Regarding: LAND DEVELOPMENT - RESUBMITTAL

**MODWASH EXPNSION**

3474 WILLIAM PENN HIGHWAY, WILKINS TWP, ALLEGHENY COUNTY, PA

In response to the comments received from the municipality on April 19, 2023, for the proposed Modwash expansion located at 3474 William Penn Highway in Wilkins Township, we wish to offer the following responses in black bold text:

SHEET NO.  $\mathsf{E}\mathsf{-}\mathsf{D}\mathsf{A}$

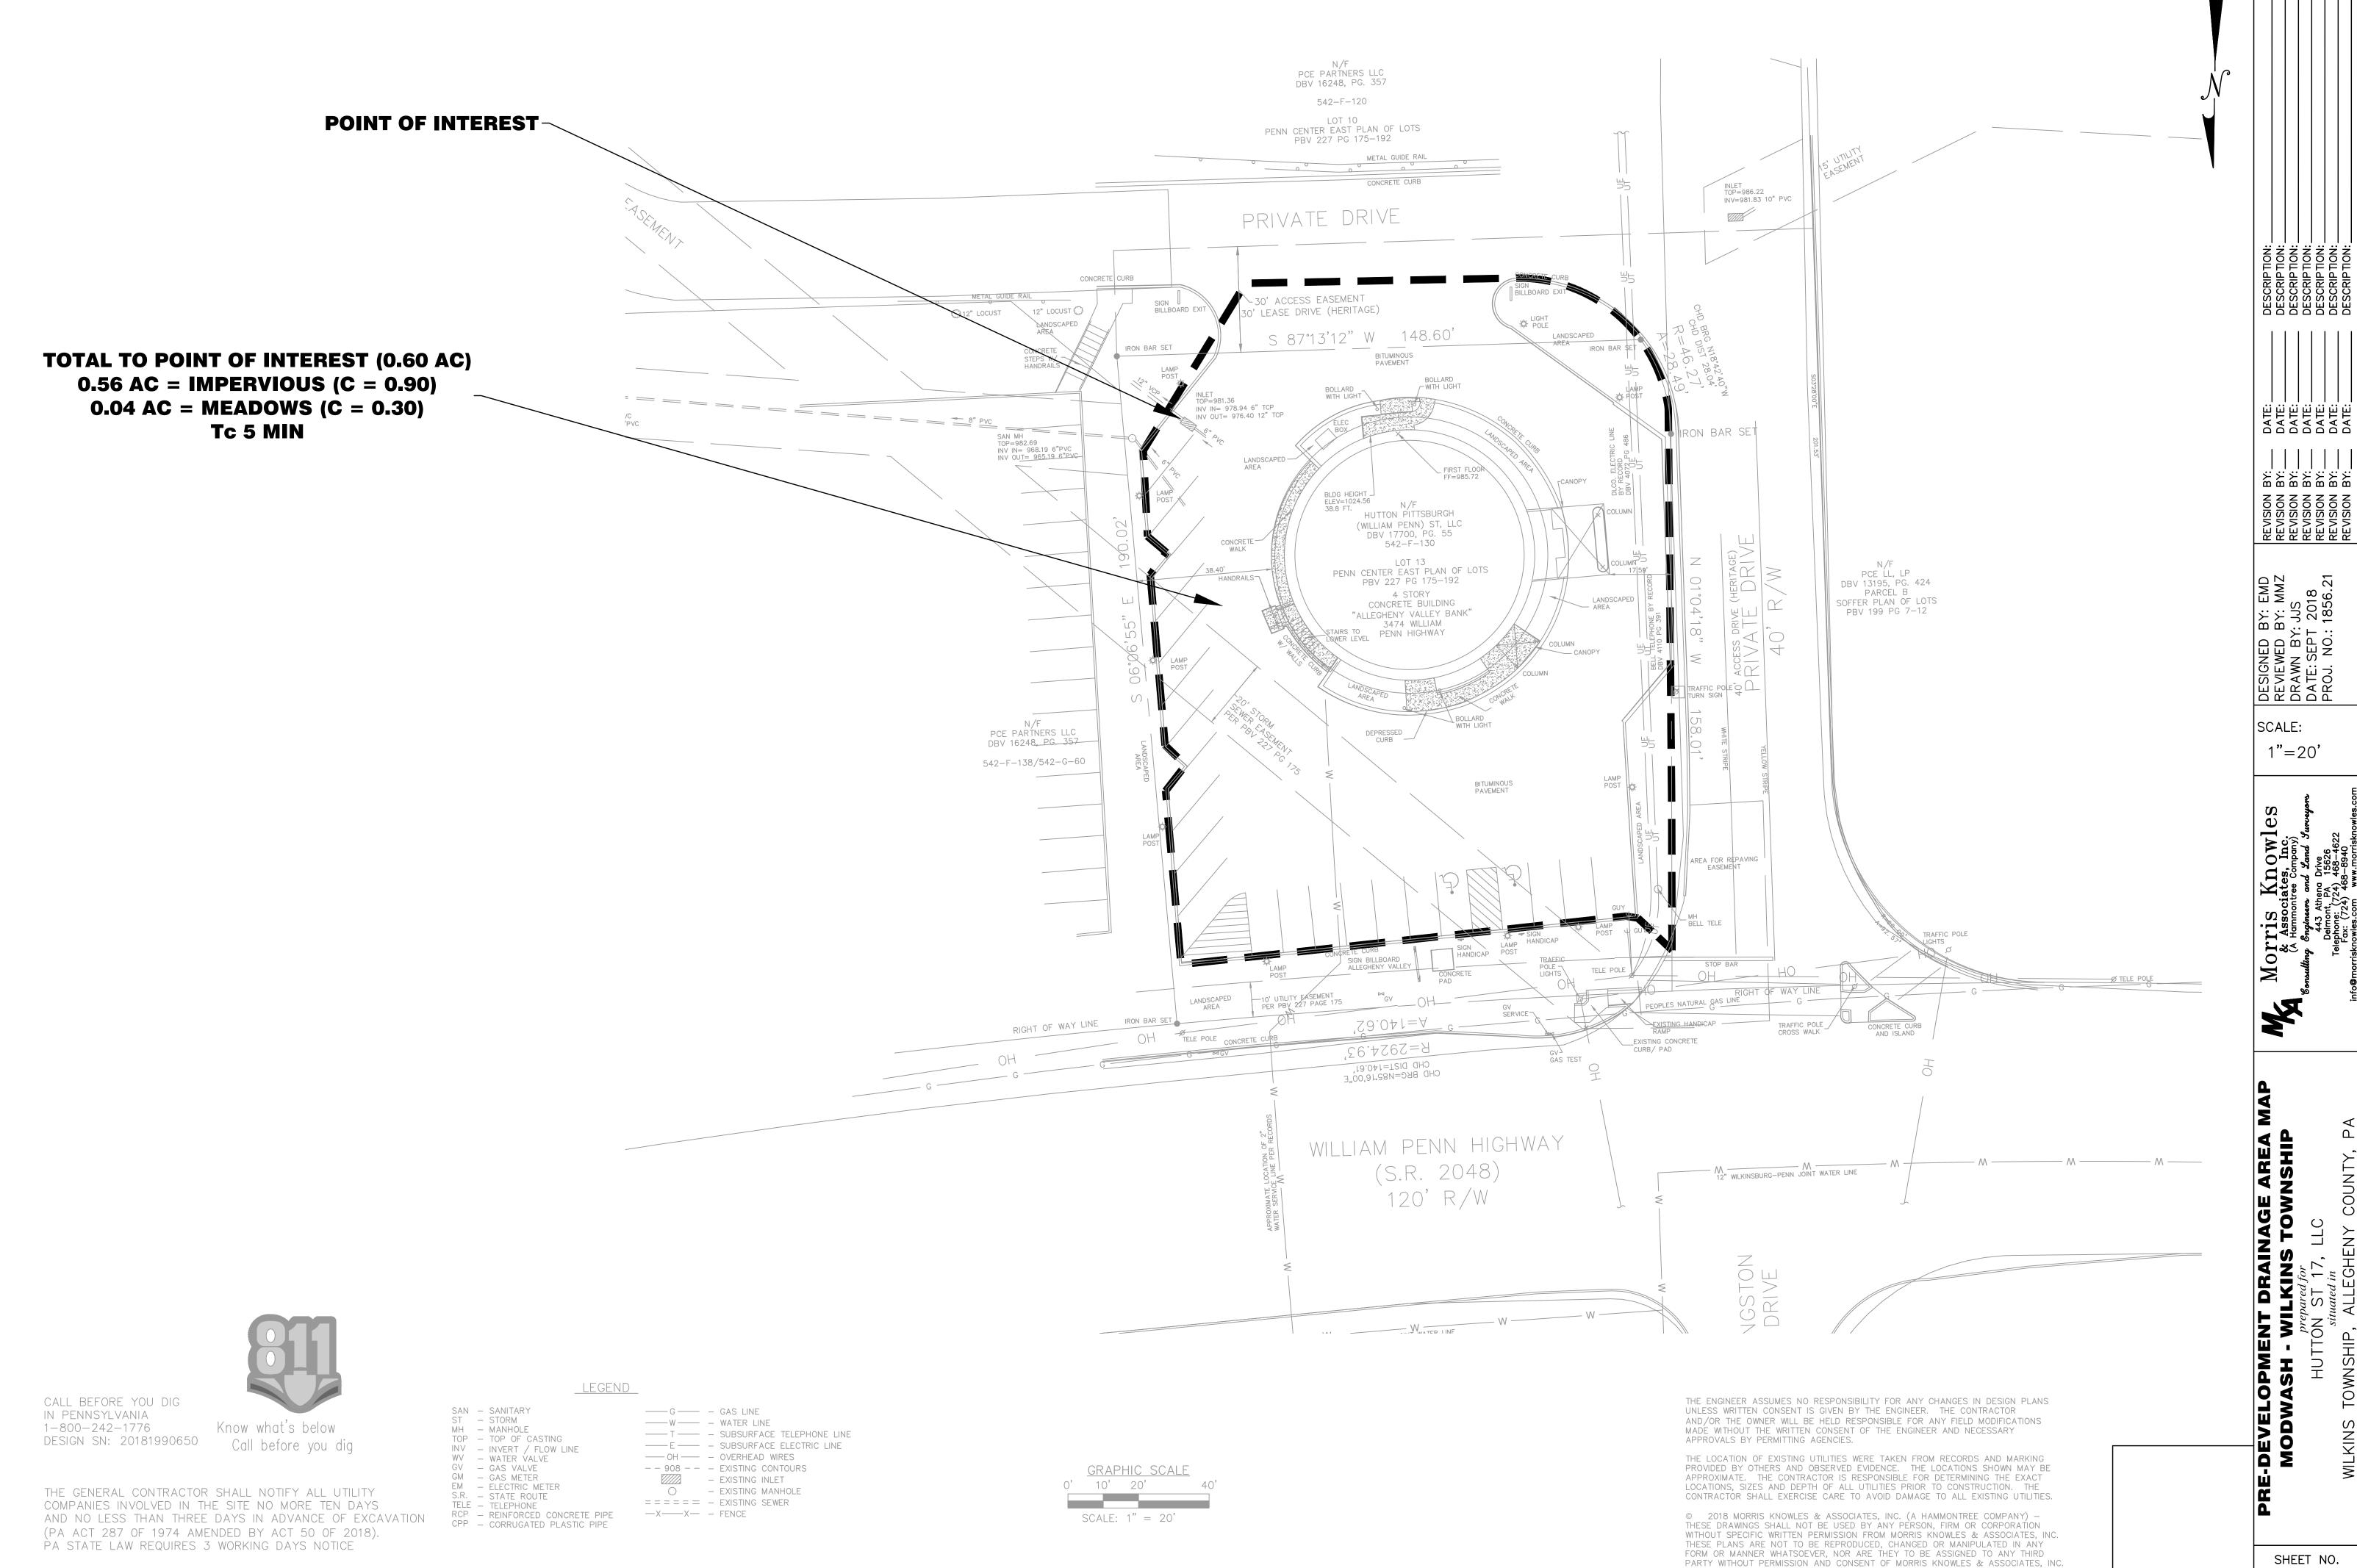
8. The proposed development in "post" condition does not appear to be factored into the predevelopment drainage areas. Pre and Post areas should match to receive an accurate runoff volume from the site.

Response: Please refer to the update drainage area maps in the PCSM narrative. The "Post" condition includes more area, as the Point of Interest 1 is capturing more runoff onsite than the pre-development site.
